Item: 10(a) – Concession Building/Plaza Design Development Plans

Excelsior Commons Concessions / Plaza DD Presentation

HPC Comments on Concession Building Proposal

RECOMMENDATIONS TO THE EXCELSIOR CITY COUNCIL

3. Number and location of food truck stations.

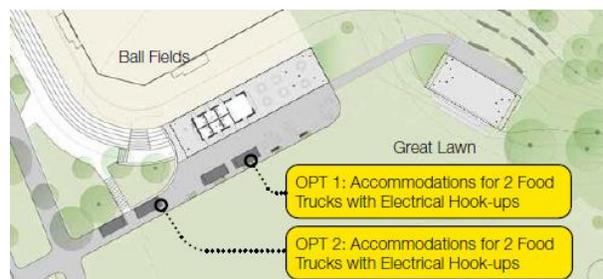
- Concern expressed about conflict between bathroom and food truck lines.
- Additional food truck electrical hookup from the building wall could be helpful.

PAC recommendation. Follow design team recommendation to establish different food truck parking locations for events (numerous spots paralleling Lake Street) and day-to-day service (2 spots on the plaza). For plaza spots, provide electrical conduit to two alternate clusters and electrify the cluster as recommended, closest to Lake Street.

5. Extent/route of vehicle access to performance pavilion.

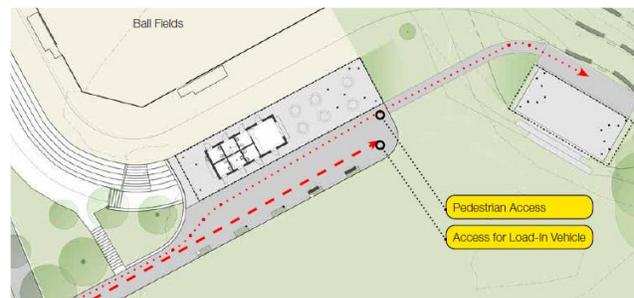
- Driving on great lawn has become a problem.
- Use landscaping to discourage driving on great lawn.
- Analyze vehicle circulation related to food truck and bathroom lines.
- Team will study emergency vehicle needs as part of code review.

PAC recommendation. Follow design team recommendation to extend vehicle access only as far as the edge of the plaza and as deemed necessary for circulation, install structured turf adjacent to the plaza. Movement of equipment beyond the plaza would be done by hand or cart.

7. Type and extent of plaza amenities and furnishings.

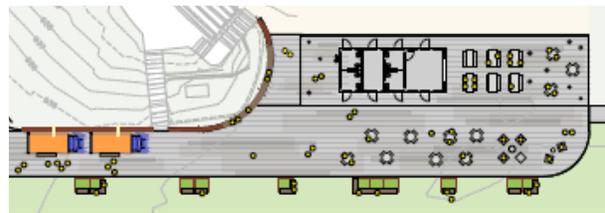
- Locate planters to discourage driving on great lawn.
- Analyze how food trucks circulate.

PAC recommendation. Follow design team recommendation to furnish plaza with picnic tables under the canopy and movable furnishings on the open-air portion of the plaza. Use planters and landscaping at plaza edges to control vehicle circulation.

10. PAC desire for greater green room program and layout scrutiny/evaluation.

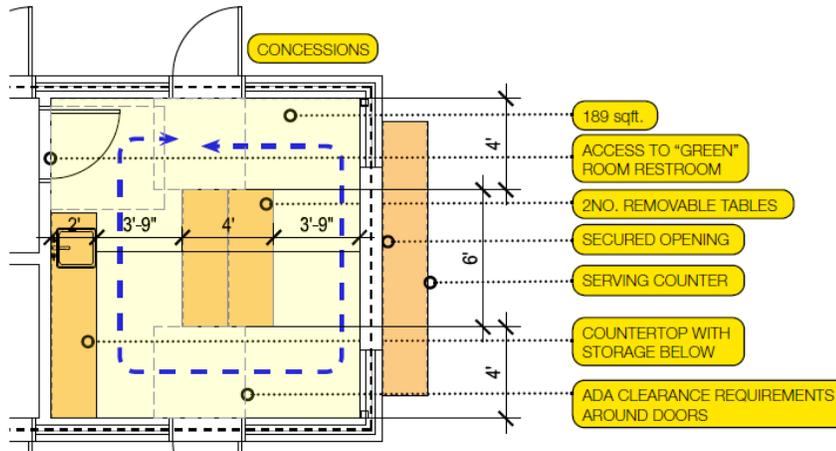
- Maybe too much space dedicated to green room.
- We don't know how this space will be used.
- Keep the space flexible. Make as multi-use as possible.
- Storage is an ongoing request by partners/users. Need countertop space and under-counter locked cabinets.

PAC recommendation. Follow design team recommendation to design green room as flexible space and include some minor storages features.

2. Format & Quantity of Interior Bathrooms. Updated

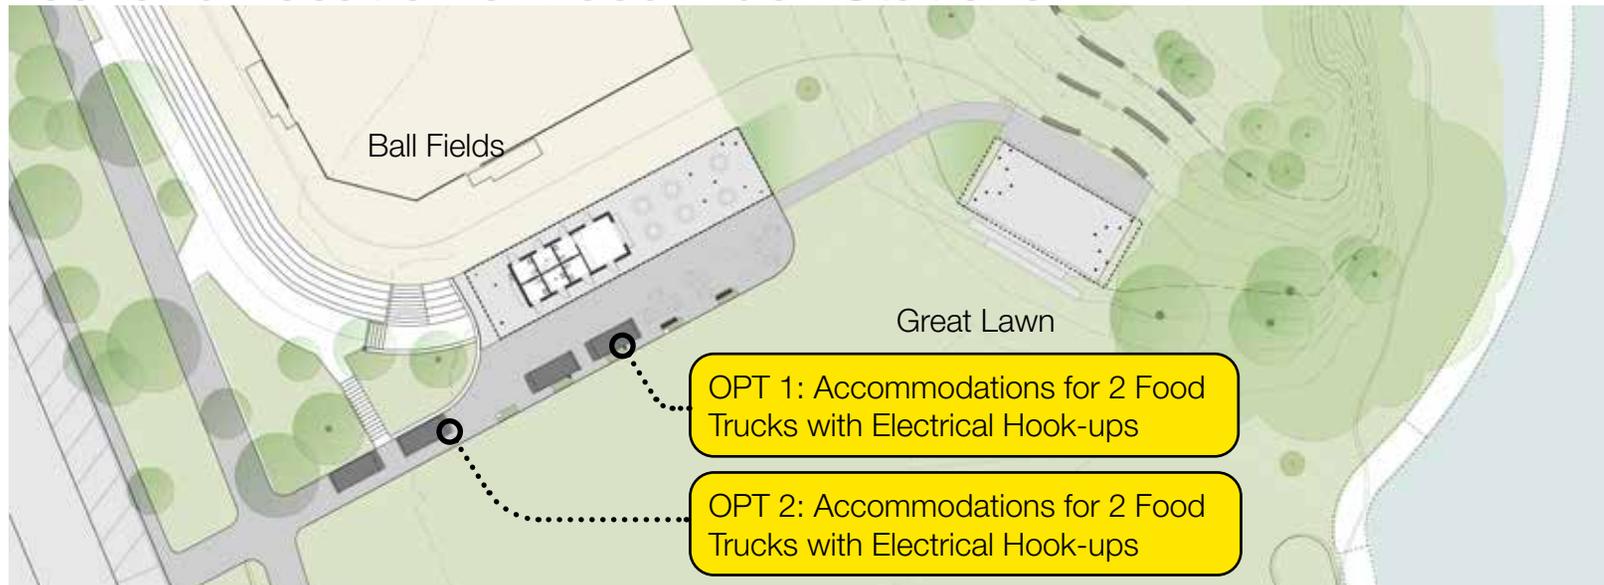
- Helpful to hear analysis by design team that suggests four toilets are adequate for crowds up to several hundred.
- Concern expressed about two doors facing ballfield and two facing plaza. Concern that bathroom doors on the ballfield side will not function well for events.

- Concern that more portables (because of fewer permanent toilets) will raise event costs.
- Good signage will be important.
- Consensus layout opinion: cluster bathroom doors on west and south sides.

Updated design: Four separate unisex restrooms with accessible doors for two restrooms on the North, and the other two located on the West.

4. Extent and Format of Green Roof

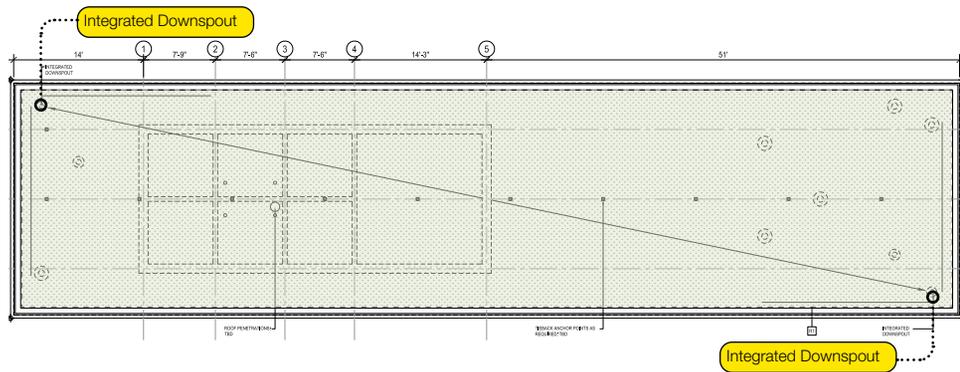
- Questioned whether the green roof is appropriate in the historic context of The Commons
- Discussion included: Creates a “softer look” for the building; helps soften the structure visually; adds to the greenery and openness of The Commons
- Concluded that it is appropriate
- Questioned whether the cost of the green roof is worth it; could that money be better spent elsewhere on the project
- Want to be sure that the green roof will function over time as expected; would be useful to look at the green roof at the Arboretum to understand maintenance requirements and how it functions over the long term

- A question about whether green roof can be removed in the future w/o damaging roof integrity? Yes.
- Question about added costs? Green roof capital cost is a line item in the project budget. There are annual plant maintenance costs. Green roof substantially extends the life of roof membrane, resulting in reroofing savings.

With the implementation of the green roof, the project is at a net zero change in impervious area. The green roof will fulfill the requirements for the watershed district and we don't need to pursue the irrigation reuse vault. PPA

8. Recent design team recommendation to alter (twist) the roof design to more closely reflect the performance pavilion.

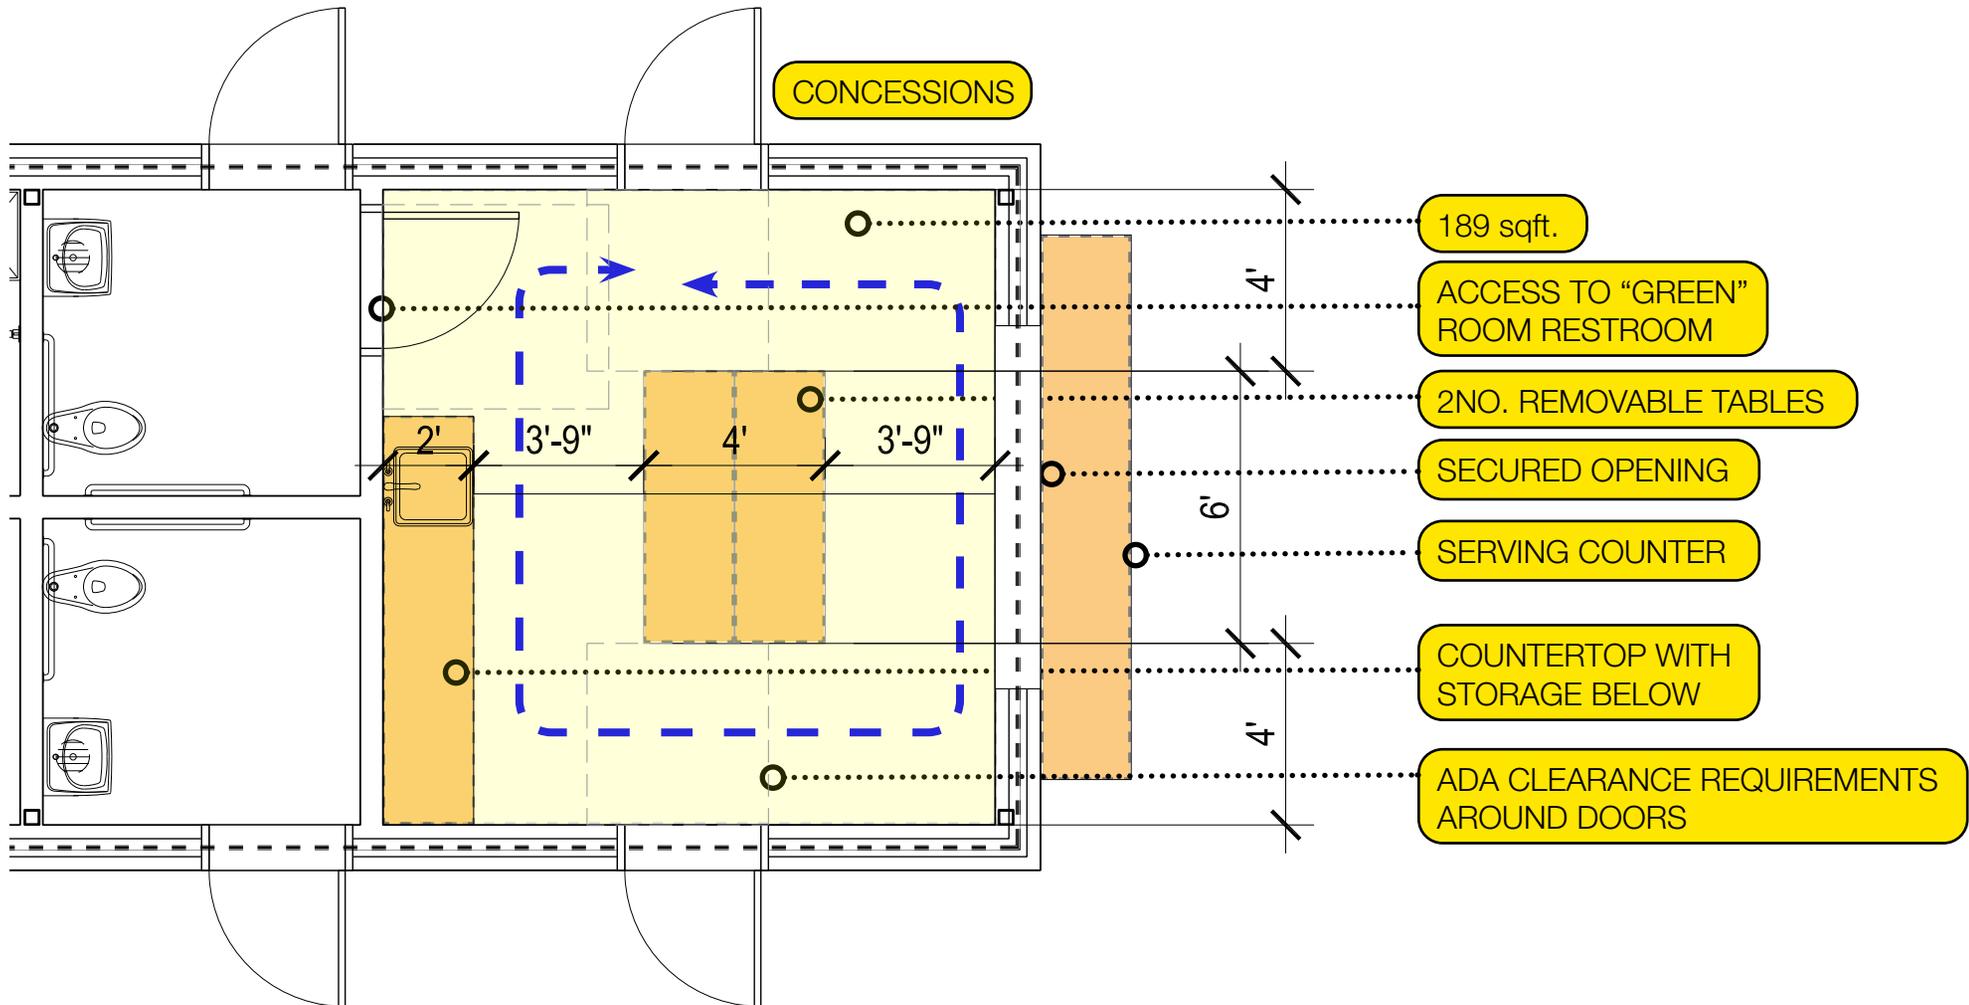
- Concerned raised about overall length of roof while others expressed excitement about the amount of covered seating.
- Twist is so slight, it doesn't call overdue attention or detract from pavilion.

Option 1 Current Design: “Twisted” Roof with “irregular” spaced columns to match band shell, reduced overall height, and clerestory
